From: Byers, Harris <Harris.Byers@stantec.com>
Sent: Thursday, April 18, 2019 1:13 PM
To: Choi, Christopher; April Kroner; Paul Braun; kmcdaniel@manitowoc.org
Cc: Beggs, Tauren R - DNR; Ramanauskas, Peter; Cull, Whitney
Subject: Second Round of Sampling at Mirro
Attachments: Figures 1-4 - Proposed Sample Locations.pdf

From the email exchanges earlier this week, below is a description of the anticipated scope of work for the second round of sampling at the Mirro facility in Manitowoc. Figures illustrating proposed sampling locations are attached. COCs and sampling strategy presented in Table 1 and Table 2 of the Workplan remain valid. Depending on groundwater quality (data expected April 24), this scope may be further adjusted to maximize project benefit in the field. Will let you know of any substantial changes.

Figure No. **2**
 Title **Figure 2. Proposed Sample Locations in the Loading Dock Area**
 Client/Project
 City of Manitowoc
 USEPA Brownfield Assessment Grant
 Hazardous Substances
 193703931
 Prepared by HLB on 5-22-18

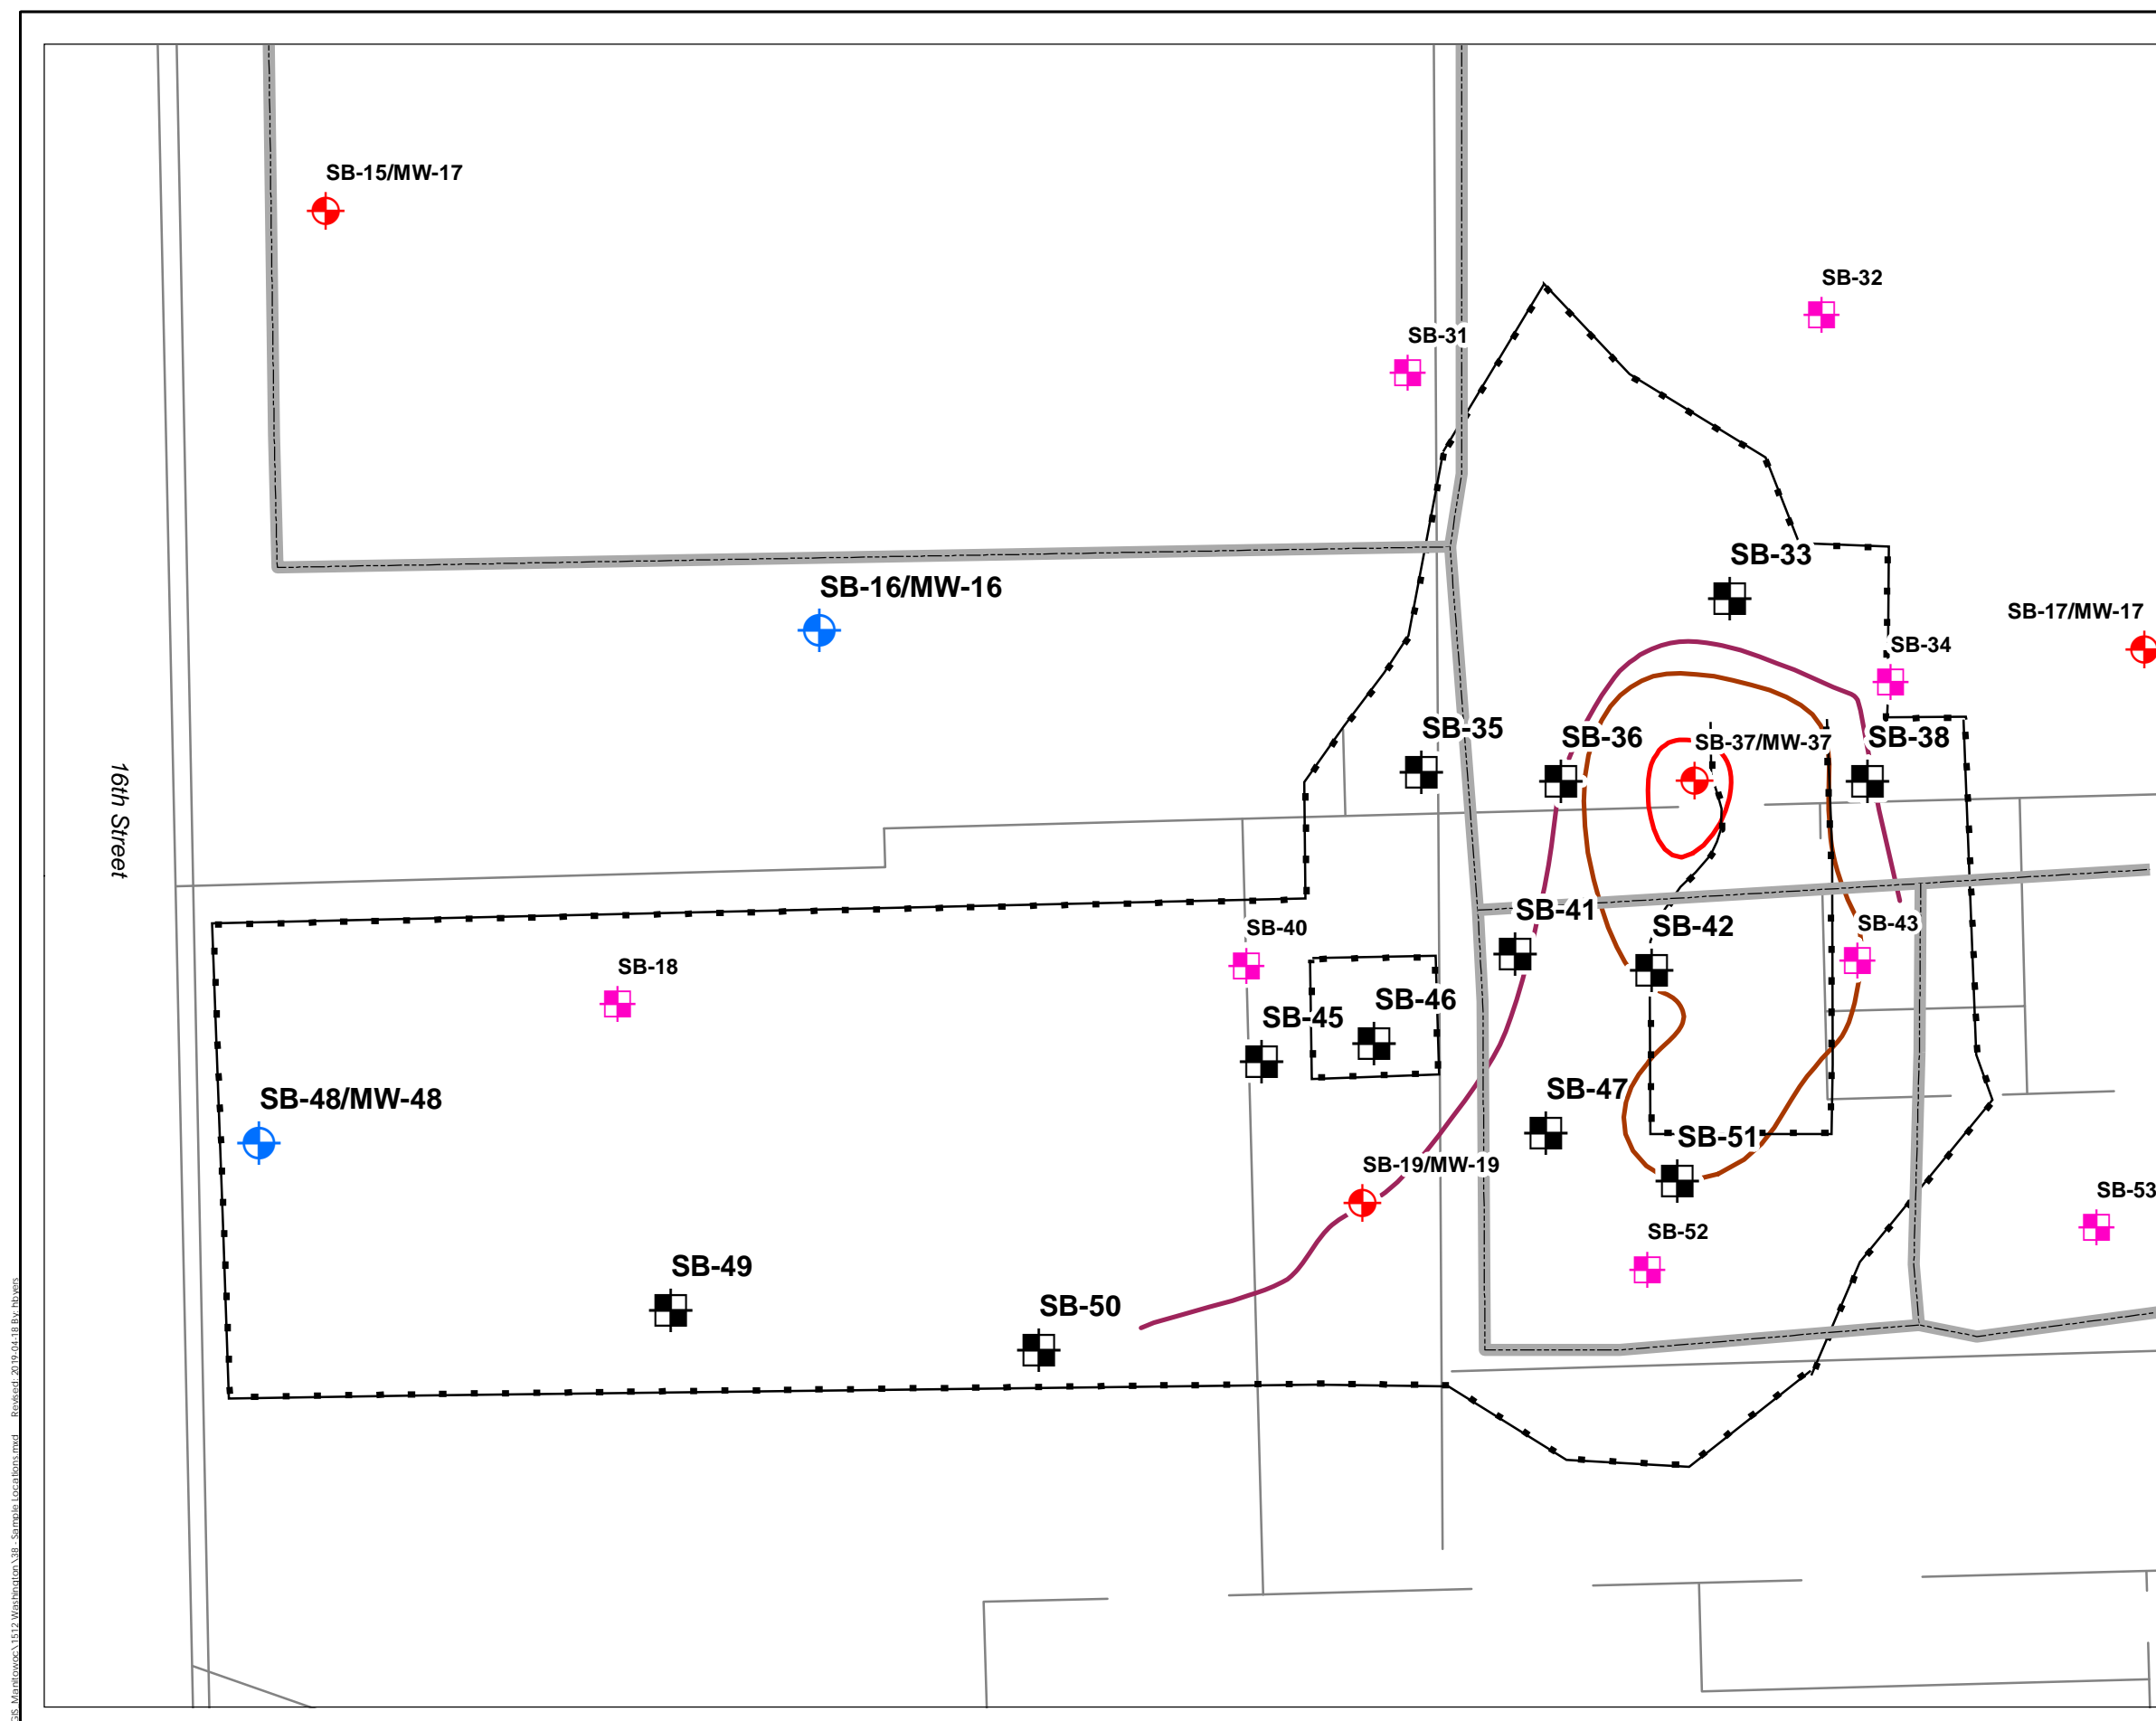
- Complete proposed borings at predetermined locations; no TWs to be constructed
- Focus sampling of sentinel borings to near-surface (0.5-1) and at locations with significant (e.g. > 3 IU) PID measurements
- Depending on groundwater quality at MW-37, SB-33 may be completed as a MW
- Depending on groundwater quality at MW-19, SB-50 may be completed as a MW

Figure No. 3
 Title
Figure 3. Proposed Sample Locations in Area 8
 Client/Project
 City of Manitowoc
 USEPA Brownfield Assessment Grant
 Hazardous Substances
 0 3.5 7 Feet
 193703931
 Prepared by HLB on 5-22-18

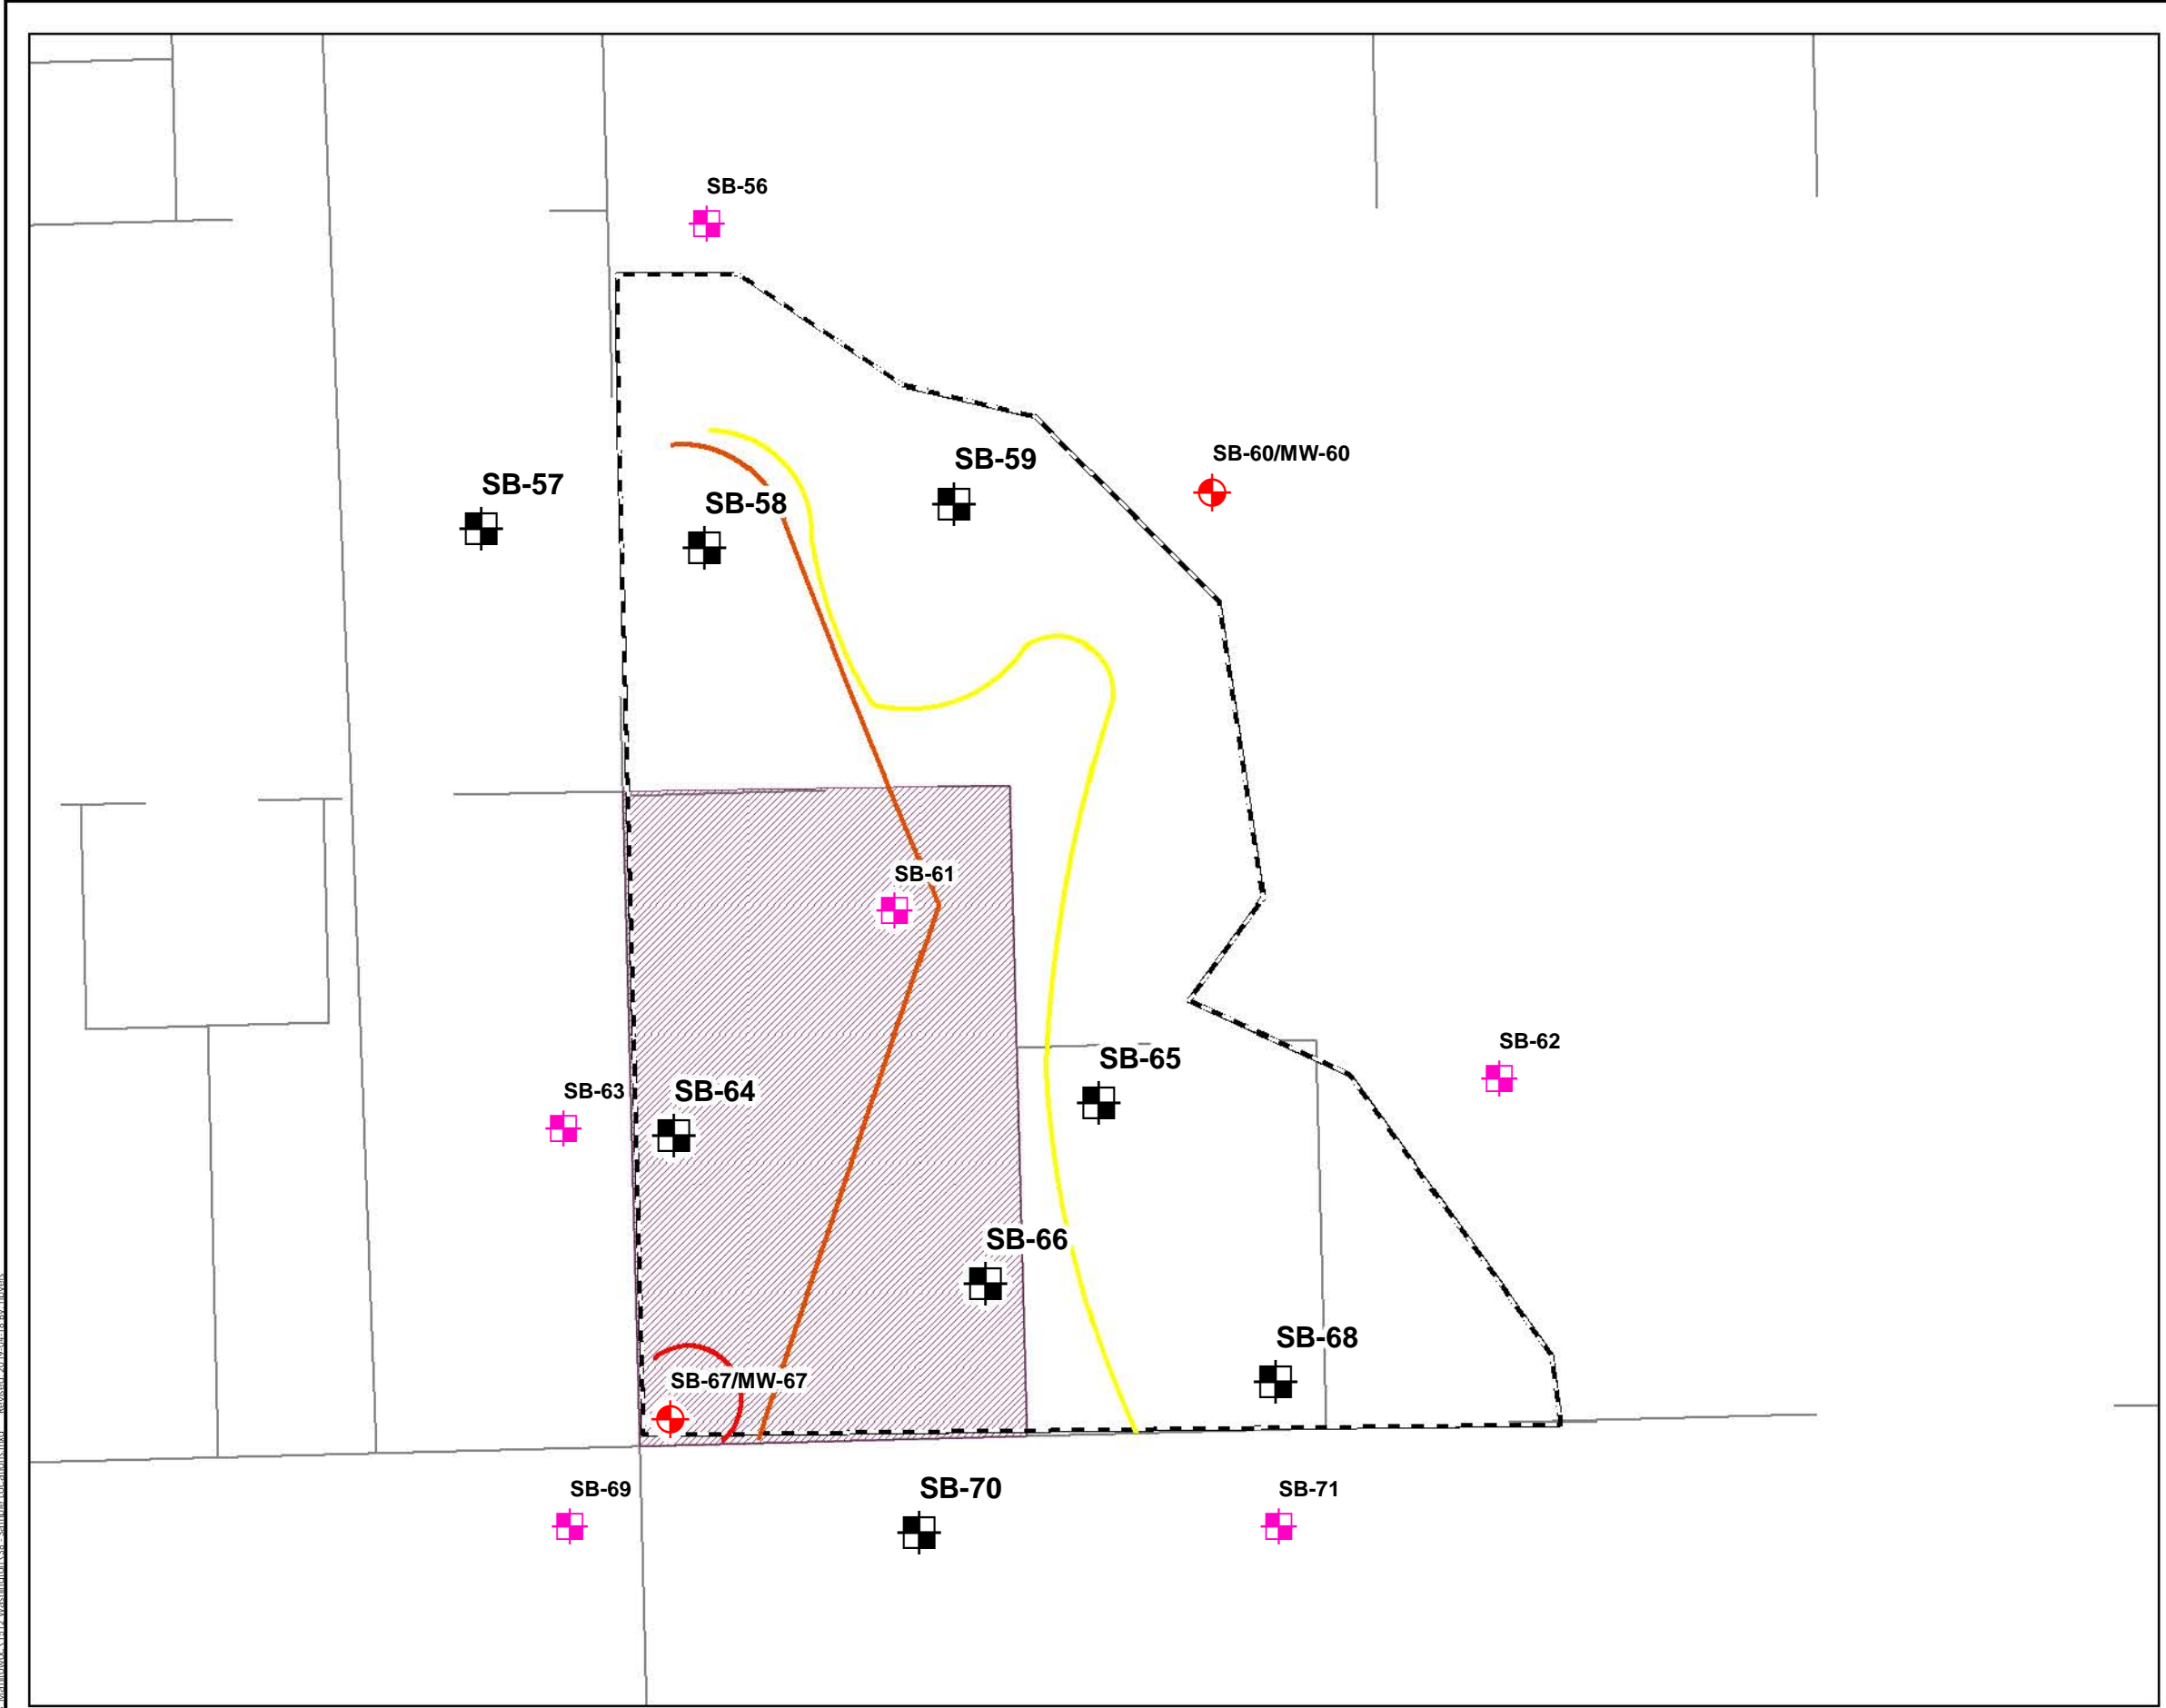
- Complete proposed borings at predetermined locations; no TWs to be constructed
- Focus sampling of borings to near surface (0.5-1)
- Complete proposed borings at pre-determined locations. Omit SB-55 (no PCB impacts at SB-56)
- Depending on groundwater quality at MW-67 (source area) and MW-60 (downgradient), one or more boring may be completed as a MW
